REMARKS*Claim Rejections Under 35 U.S.C. § 112*

ANNOTATED MARKED-UP DRAWING
Inventor: Andrei Mihnea
A METHOD FOR PROGRAMMING AND ERASING AN NROM CELL
Atty Docket No. 400.234US01 Serial No. 10/636,173

Fig. 1A

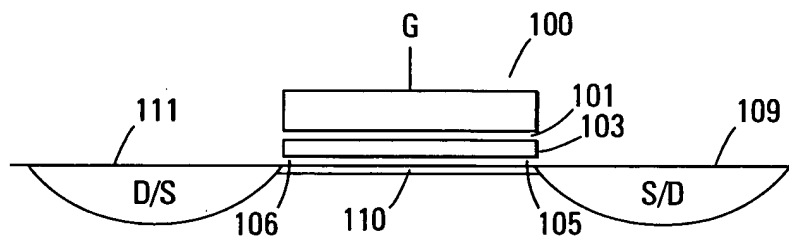
The drawings were objected to as failing to comply with 37 CFR 1.83(a). The Examiner stated that the two source/drain regions and an NROM cell embedded in a CMOS device must be shown or canceled from the claims. Applicant respectfully traverses this objection.

The two source/drain regions are clearly shown in both Figure 1A and 1B as reference numbers 109 and 111. In order to fit the labels “source/drain” into the small areas, these terms had to be abbreviated “D/S” and “S/D”. These areas are clearly described as source and drain at paragraph 22 of the specification. While the phrase “drain/source” is not explicitly used in the specification, it is well known by those skilled in the art that only one area (109 or 111) is a drain and the other area (111 or 109) a source at any one time. Paragraph 22 clearly states that the

source and drain functions change with the direction of operation of the cell. Therefore, while one area 111 is a drain (i.e., D), the other area 109 is a source (i.e., S), hence the D/S label. Similarly, when the first area 111 is a source, the other area 109 is a drain, hence the S/D label. Therefore, the two source/drain and drain/source regions that are recited in the claims are clearly discussed in the specification and shown in the drawings.

Fig. 2

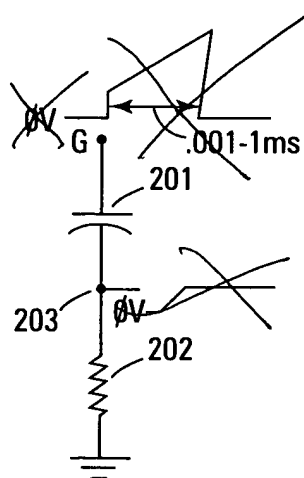
The drawings were objected to as failing to comply with 37 CFR 1.84(p)(5) because they included the following reference character(s) not mentioned in the description: 0V and .001-1ms in Fig. 2; CONTROL, DATA, and ADDRESS in Fig. 6. Applicant respectfully traverses this objection.

The labels “0V” and “.001-1ms” are discussed in the specification at paragraph 29 where it states that “[a] linear ramp voltage is applied to the control gate of the cell 307. In one embodiment, this voltage starts in the range of 0 to 6V and goes up to 4 to 12V for a time in the range of 0.001 – 1 millisecond.” Since the circuit of Fig. 2 is the equivalent circuit of the NROM cell of Fig. 1 and the gate connection “G” is clearly labeled in both figures, it is clear that the ramped voltage of Fig. 2 with the labels “0V” and “.001-1ms” is being applied to the gate connection as is referred to by paragraph 29. However, in the interest of expediency, Applicant has deleted these references from Fig. 2.
